Guidance for Development of Response to Generic Request for Additional Information on Fire Individual Plant Examination for External Events (IPEEE)

A Supplement to EPRI Fire PRA Implementation Guide (TR-105928)

SU-105928

Final Report, March 2000

Figure 1 HRR Scaling Factor for Cable Trays within 6' of a Ceiling or Wall Corner

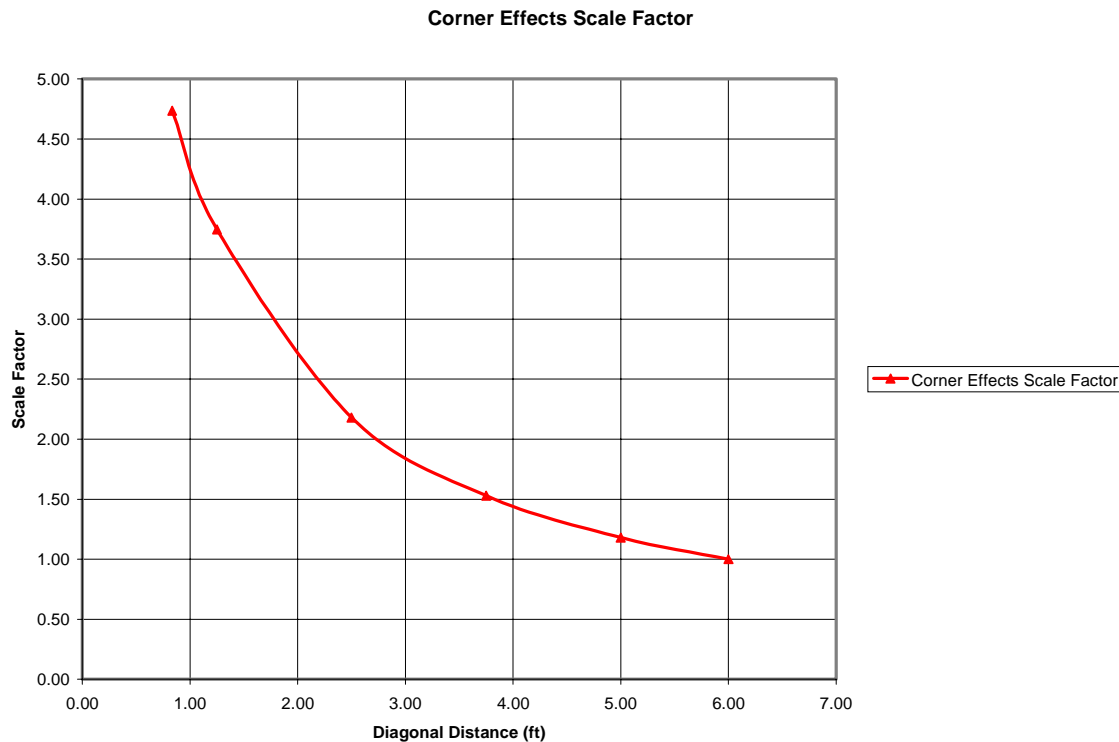
3.3 RAI Question 3 - Fire Propagation in Horizontal Cable Tray Stacks

- Tray spacing is at least 10.5" vertical separation between trays in the same stack and at least 8" horizontally between tray stacks; this is the minimum separation allowed by RG 1.75

- Fire size is limited to 190 Btu/s
- The HRR for trays located within 6' of a ceiling or wall corner should be scaled as defined by Figure 1.

- Walkdowns or drawing review may be required to determine, from the candidate scenarios, any involving tray stacks located within 6’ of the wall/ceiling corners. For such fires, the scenarios should be reevaluated and the heat contribution to the compartment increased by the appropriate scale factor shown in Figure 1.

Figure 2 - A Pictorial Guide for Identification of Fire Scenarios Affected by Cable Ignition Temperature

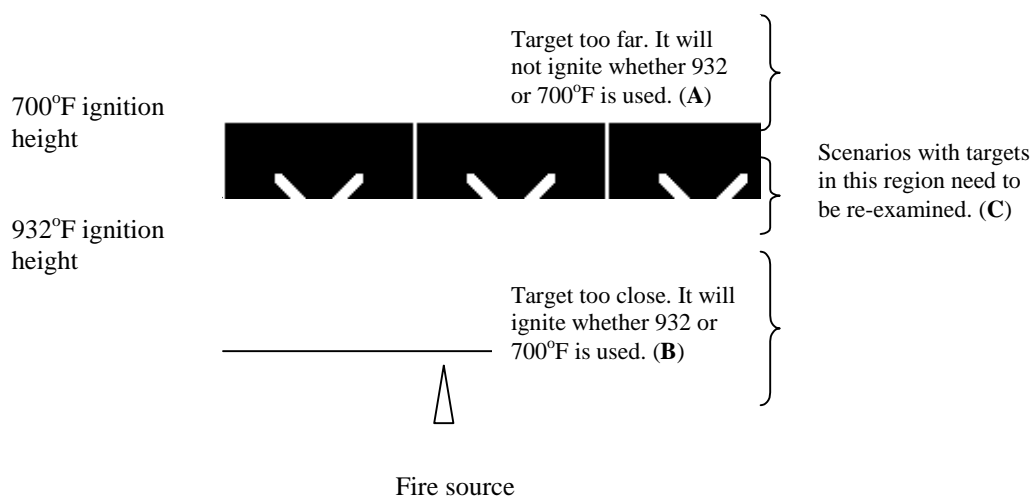
3.16 RAI Question 16 - Piloted Cable Ignition Temperature

Existing detailed fire modeling (FIVE step 3 or Implementation Guide Step 5.3) should be reviewed to identify potentially affected compartments and/or scenarios. These are the scenarios that consider ignition of cables and subsequent damage to additional targets of interest. Fire compartments that were subject to detailed fire modeling (i.e., limiting damage in the compartment) and used cable ignition temperature of 932°F may require further evaluation.

These compartments should be reviewed to identify exposed cable in proximity to the ignition source(s) that would experience a plume or ceiling jet exposure greater than 700°F, yet less than 932°F. Scenarios where the exposed cable is either too close to the fire source and will be ignited with either 700 or 932°F (figure 2 below, region A) or is too far and will not be ignited by 700 or 932°F (figure below, region B) can be excluded. Only scenarios with exposed cables in region C need to be re-evaluated. A scoping evaluation process, potentially followed by walkdown of the specific scenario(s), is recommended. The purpose of the scoping evaluation is to facilitate identification of any affected scenario in the field.

An example of such scoping evaluation is demonstrated in Table 2 that calculates the range of (FIVE) plume ignition heights WITHIN which the exposed cable must be located to be ignited at temperatures between 700°F and 932°F. Plant-specific information should be prepared prior to the walkdown. Caution should be exercised when dealing with ignition distances to account for uncertainty in numbers (i.e., do not preclude a scenario if the target is inches out of the ignition height).

Figure A.1 Sensitivity of the hot gas layer temperature predictions to the assumed heat loss factor

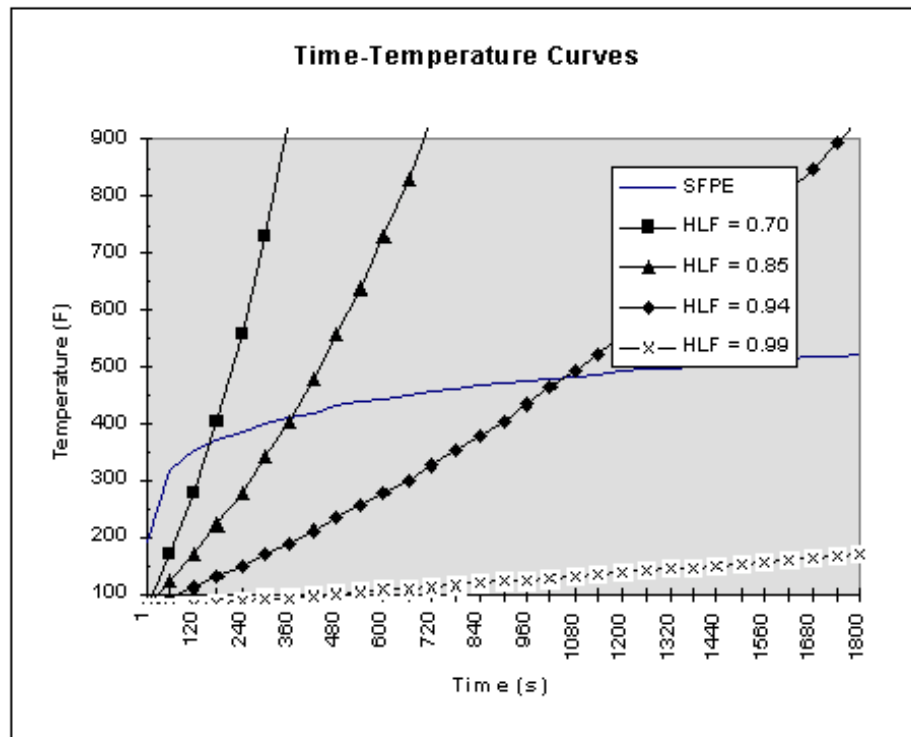
For each scenario where the hot gas layer temperature was calculated, please specify the heat loss factor value used in the analysis. In light of the preceding discussion, please either: a) justify the value used and discuss its effect on the identification of fire

Figure 4-1 Comparison of Hot Gas Layer Temperatures Predicted by the FIVE Models (Virtual Surface at the Floor) with Results of Test #4 (Fast Growing Floor-Based Fire).

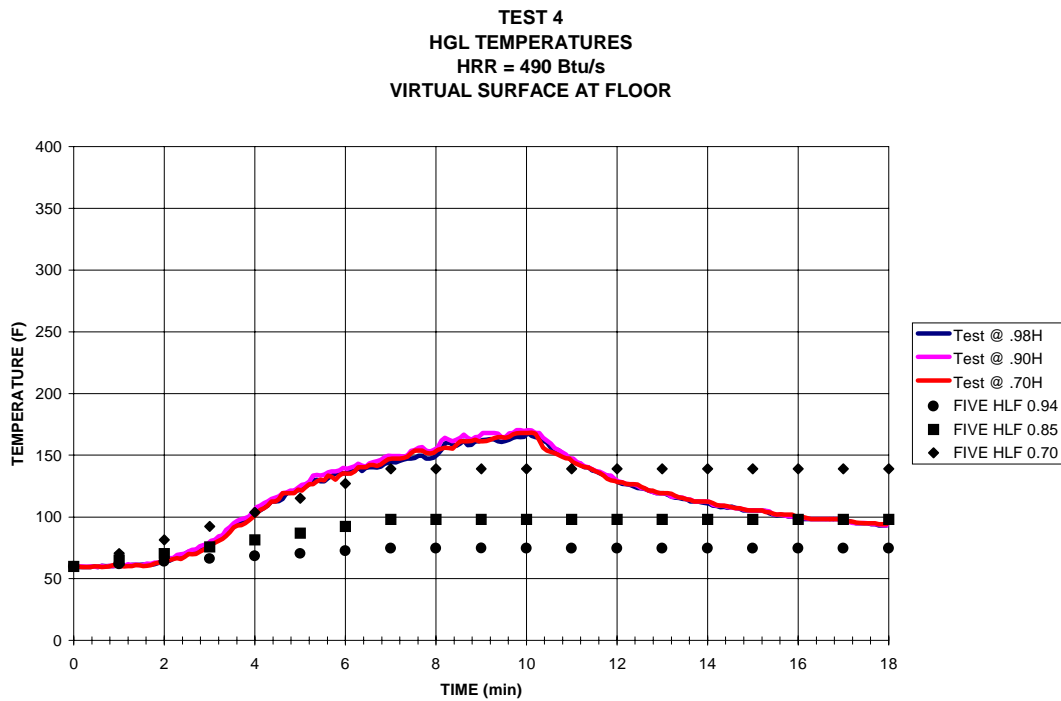
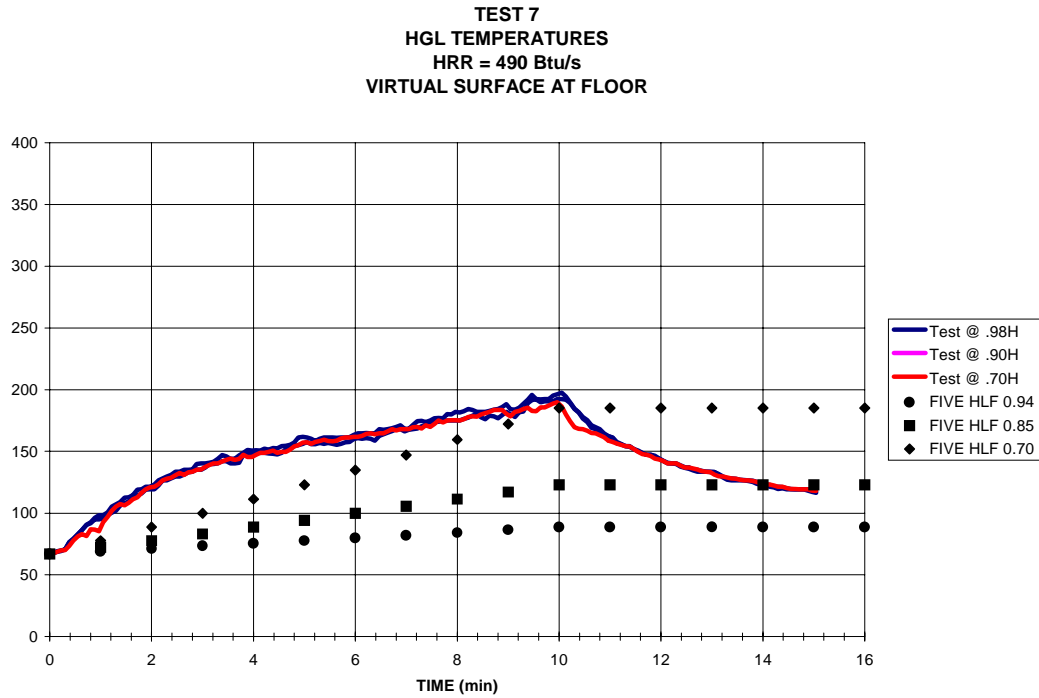
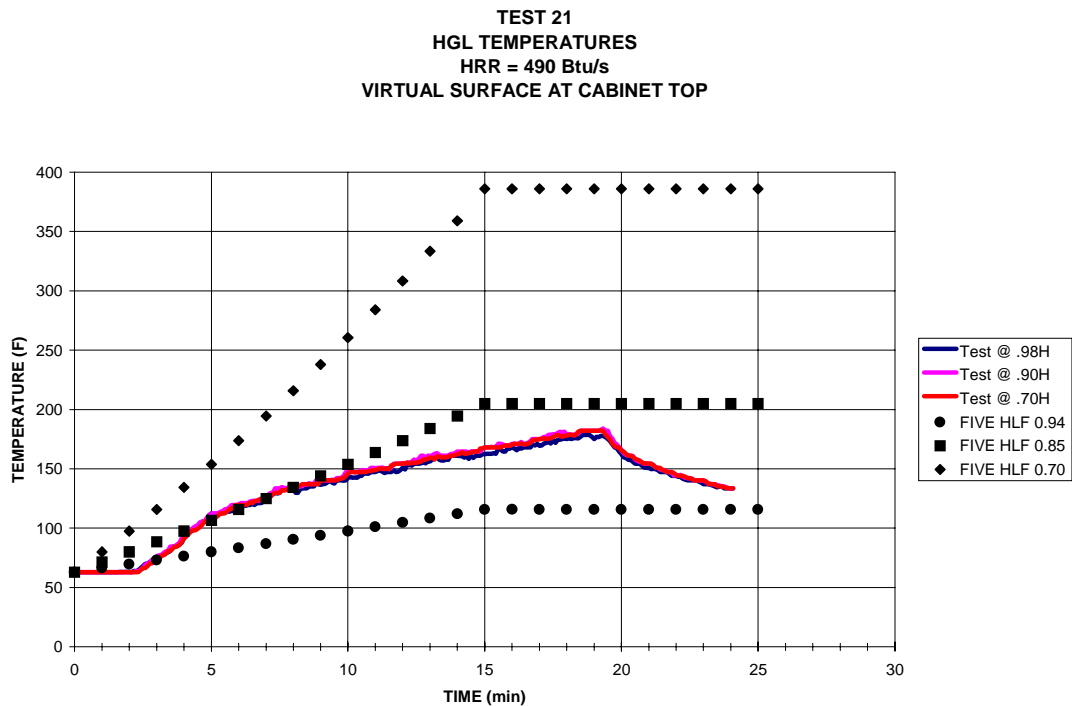
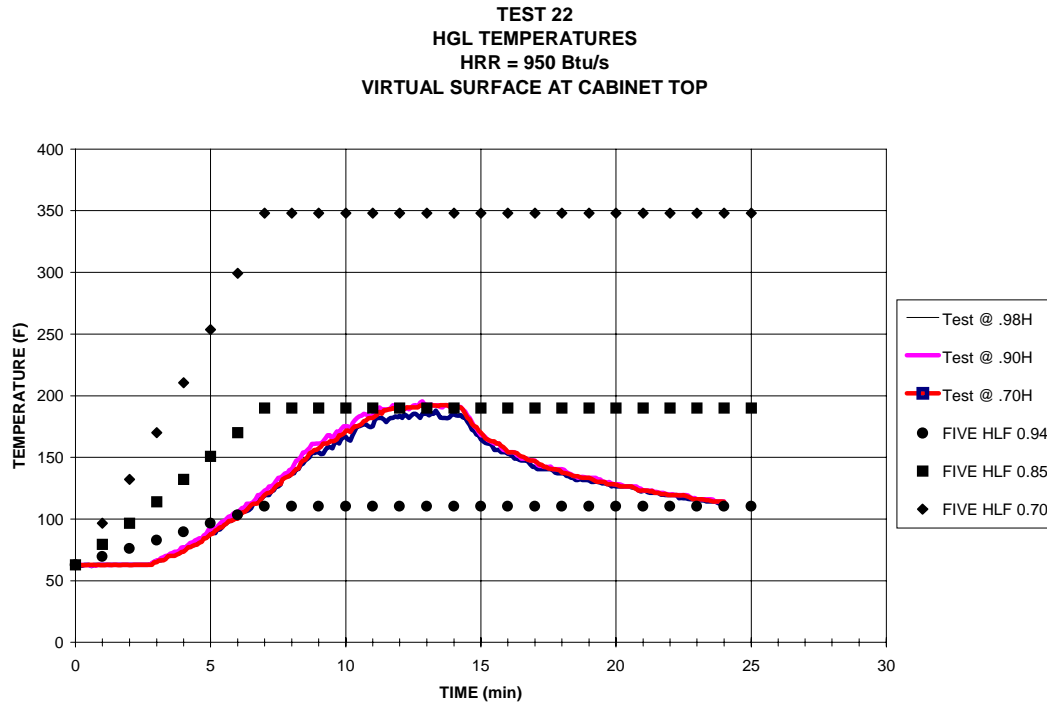
3.2 RAI Question 2 - Heat Loss Factor

The NRC's questions use of HLF values other than 0.7 in the FIVE fire models. However, they have indicated that when 0.7 is used, it would be acceptable to assume that the HGL descends all the way to the floor even if the virtual surface of the fire is not at the floor (e.g., cabinet fires or cable tray fires).

- b) If $HLF = 0.85$ was used for single compartment scenarios involving electrical cabinet fires or elevated cable tray fires, and the hot gas layer was conservatively assumed to descend only to the top of the cabinet or to the elevation of the lowest tray (virtual surface $0.40H$ above the floor, where H = ceiling height), the scenario need not be revised.

- c) If $HLF = 0.94$ or 0.85 was used for other single compartment scenarios, revise the HLF to 0.7 unless it can be demonstrated that the resulting damage was bounding with the higher heat loss factor and the analysis did not credit timing.

floor-based fires. A HLF of 0.85 is appropriate for fires initiated by electrical cabinets including those involving cable trays (virtual surface at cabinet top), and for overhead cable tray fires where the HGL is based on the volume above the burning tray (HGL volume = $0.60 \times \text{room volume}$, or less).

- A HLF of 0.95 is generally non-conservative except possibly for slow growing, long duration fire scenarios. This value should only be used when demonstrated to be appropriate for the scenario being considered.

Figure 3-1 Comparison of the Time-Dependent Heat Released from the Model with that Determined from Tests with IEEE 383 Cable and the Heptane Ignition Source.

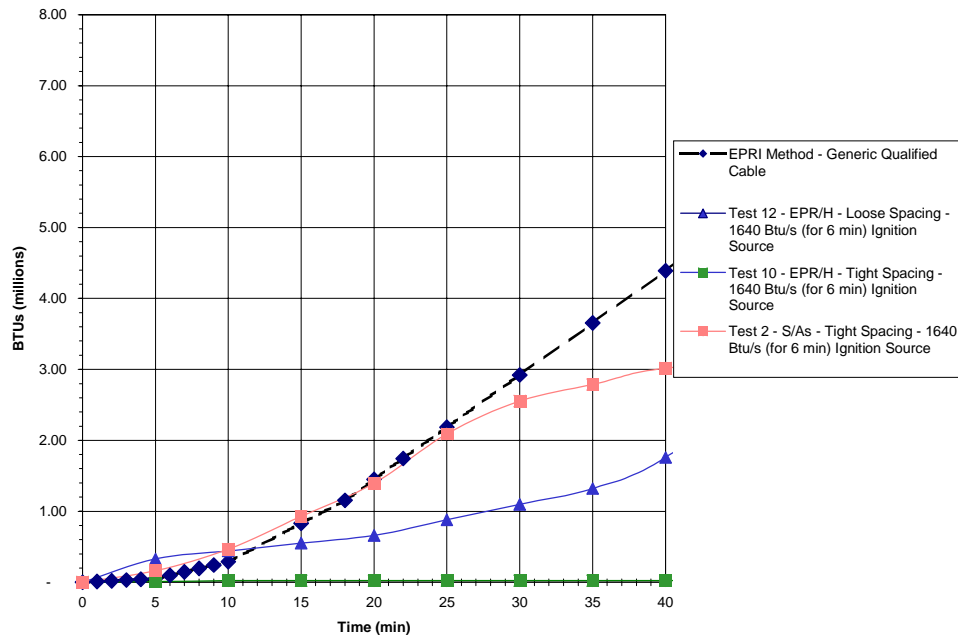
Four of the EPRI/FMRC tests (tests 2, 10, 11 and 12 from NP-1881) were Free Burns involving assemblies similar to that addressed by the model (horizontal trays with IEEE 383 qualified cable), but were ignited with a 4.5 ft² pan containing 2 gallons of heptane. Although this ignition source is substantially larger than an ignition source representative of a NPP electrical cabinet with qualified cable or transient combustible, the test data was compared with data calculated by the model.

Comparison of the time-dependent heat released from the model with that determined from these tests is shown in Figure 3-1. Data from tests 10 and 11 appeared to be essentially identical, so only test 10 was plotted.

As can be seen from the plot, the model generally provides results that bound test data even though the testing used the 2 gallon heptane ignition source. The following observations and conclusions were drawn from the comparison:
